Comment on SEARS - Proposed Dangerous Goods Facility

– Warehouse 3b Oakdale Central , Horsley Park, within Lot 21 DP 1173181

Comments are based on the publication by Willow Tree Planning ‘ Request for Secretary’s Environmental Assessment Requirements Proposed Dangerous Goods facility Warehouse 3B, Oakdale Central, Horsley Park 2 February 2016’

Figure 1 NearMap – Cleared area is Lot 3. The Warehouse 3B is proposed to occupy the northern half of the cleared area . Note Ropes Creek to the west.

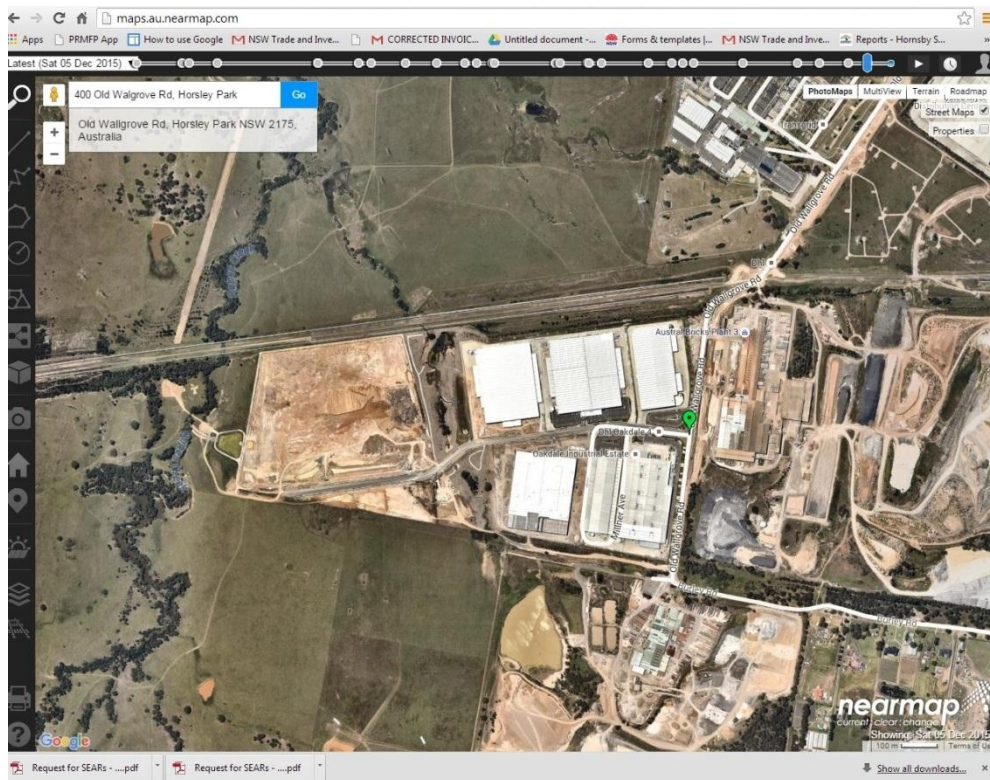
The proposed warehouse 3B will be sited within proposed Lot 3 which will be near the western end of existing Lot 21 DP 1173181. It seems that fill is being placed to raise Lot 3 above the 100year flood event. – Refer Figures 1 & 2.

Between the western end of proposed Lot 3 and the Ropes Creek Corridor is a ‘Biodiversity Lot C’. The brief report Request for SEARS document appears not to outline the role for ‘Biodiversity Lot C’.

Figure 3 - Aerial showing contours & roads. Note that the north western corner of Lot 21 DP 1173181 naturally drains to the west and north to Ropes Creek, while the central northern part of Lot 21 DP 1173181 drains to a tributary of Ropes Creek, linking with the main creek in the north of the site.

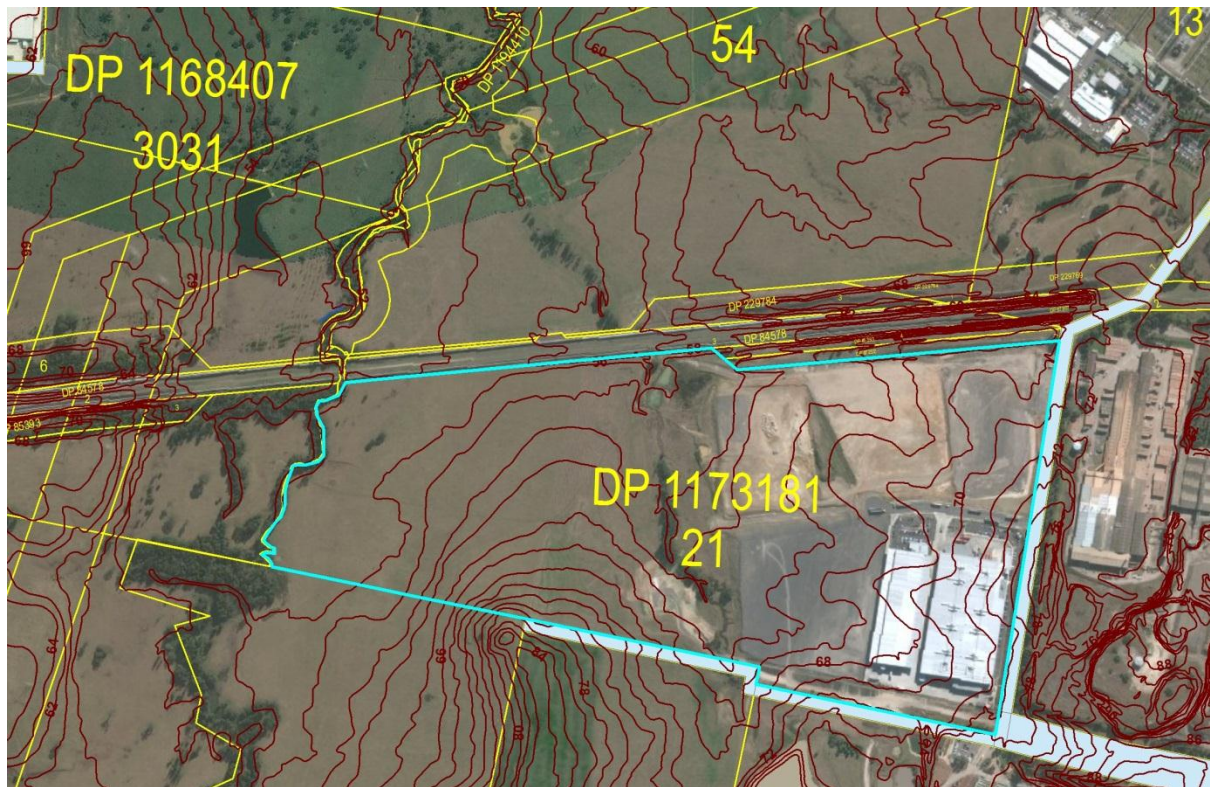
It needs to be noted that a tributary of Ropes Creek is located centrally within Biodiversity Area B, so there is potential for stormwater runoff from Bio-diversity Lot B to discharge to Ropes Creek via the tributary. Refer Figure 3.

Hence it is important that contaminants from the Dangerous Goods Facility are able to be contained before entering Ropes Creek (to the west of Lot 3) or the Ropes Ck. tributary (to the east of lot 3).
